**Aircraft Noise
Competent Authority**

Draft Regulatory Decision

Appendix L

Section 34C(8) Notice to Applicant and Response

Residential Sound Insulation Grant Scheme (RSIGS); Relevant Action proposed eligibility areas

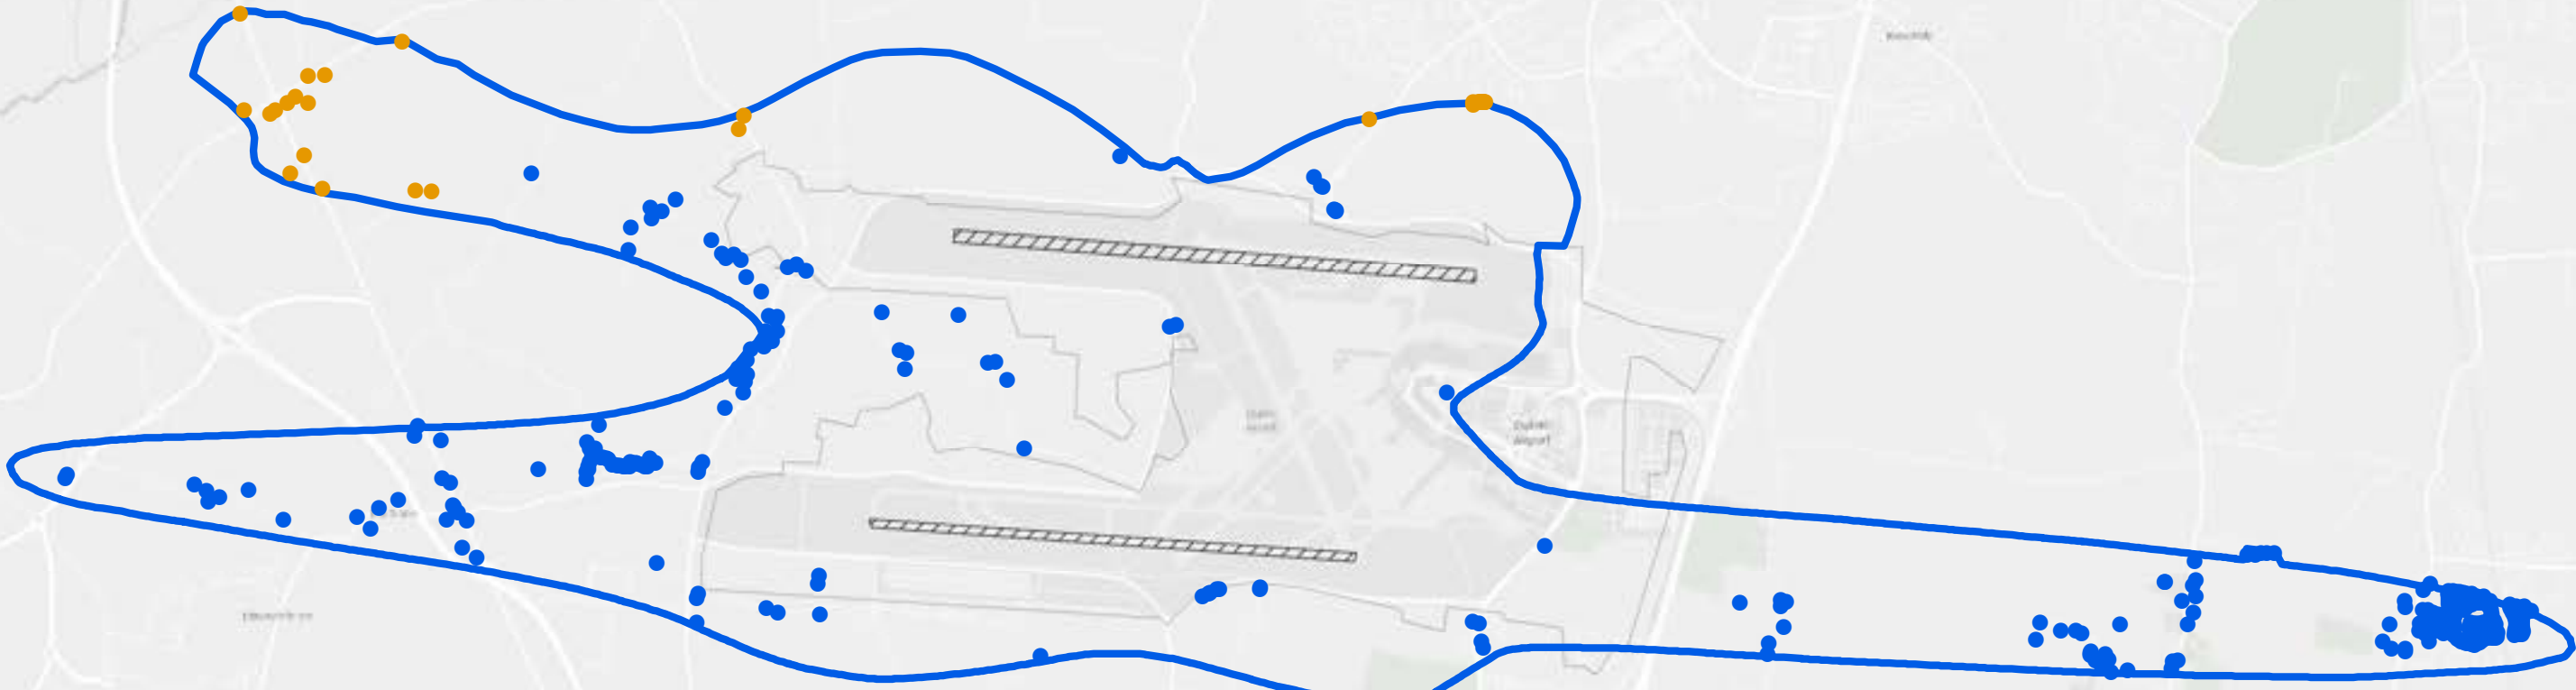
Criteria 1 Dwellings: The dwellings within the area enclosed by the 55 dB L_{night} contour based on 2025 Scenario 02 noise exposure data provided by the Applicant to ANCA on 18 June 2021; and

Criteria 2 Dwellings: The dwellings within the area exposed to 50 dB L_{night} , as a result of Relevant Action and an increase in noise exposure of at least 9 dB compared to the situation in 2025 by comparing 2025 Scenario 02 to 2025 Scenario 01 as provided by the Applicant to ANCA on 18 June 2021.

Where the eligibility contour bisects a local land boundary, the contour has been amended to reflect this.
